ATOMIC POWER COMPANY •

August 6, 1982
MN 82-156

Subject: Maine Yankee Cycle 7 CEA Modifications

MAINE YANKEE CYCLE 7
CEA BANK 5 CONFIGURATION

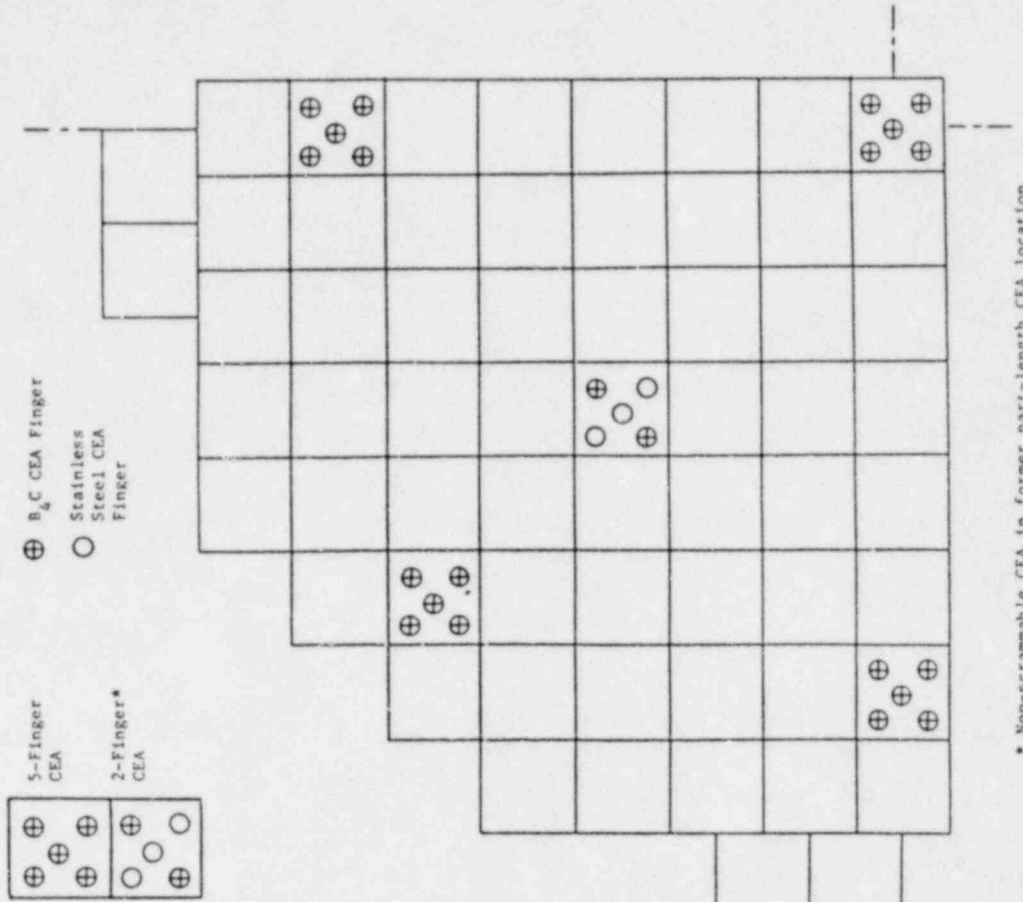
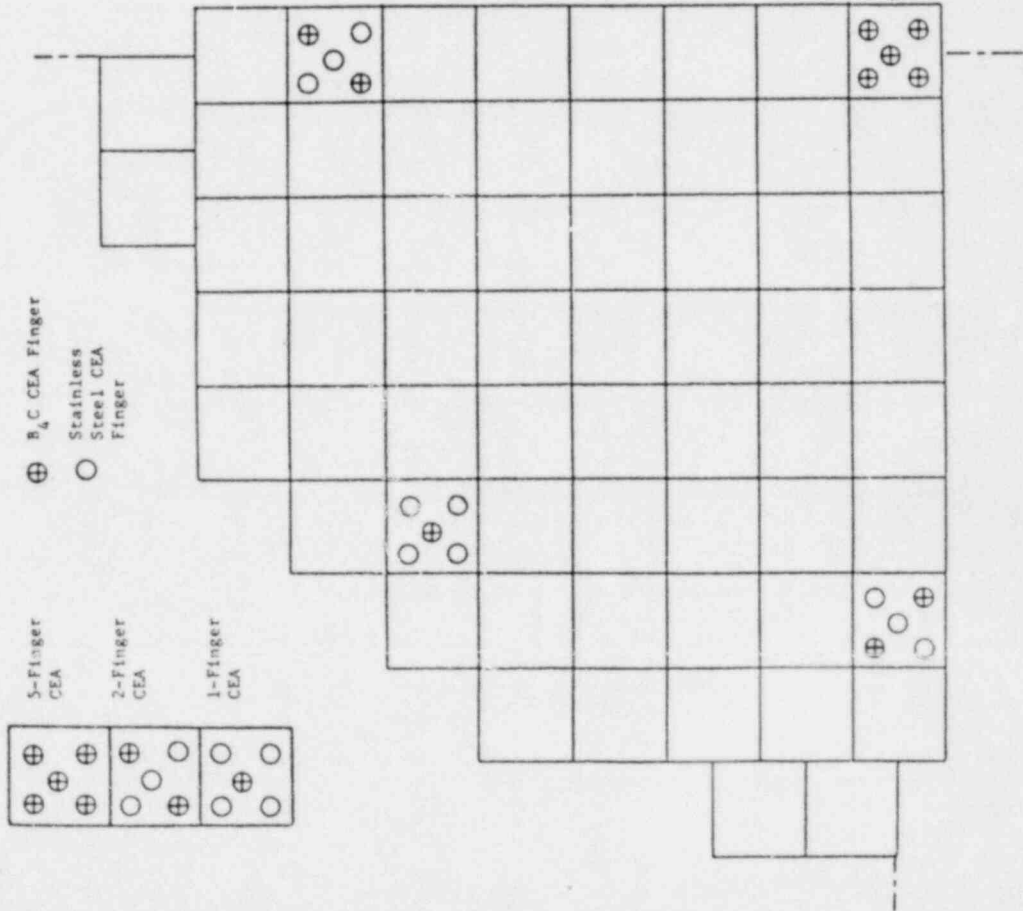
The expanded examination of cooldown transient modes associated with a postulated steamline break (SLB) accident has resulted in the need for increased margin to criticality with cooldown. This has been accomplished by modification of CEA Bank 5, the lead regulating bank.

The original and new Bank 5 configurations are depicted in Figures 1 and 2 (Attachment I). The eight part-strength CEA's have been replaced by full-strength CEA's. Four of these eight part-strength CEA's have now been added to Bank 5 for better local power distribution control. These additional Bank 5 CEA locations formerly comprised one of the part-length CEA banks. The full length CEA's in these locations are nontrippable. Please note that the part-length CEA banks have not been employed in any previous cycle.
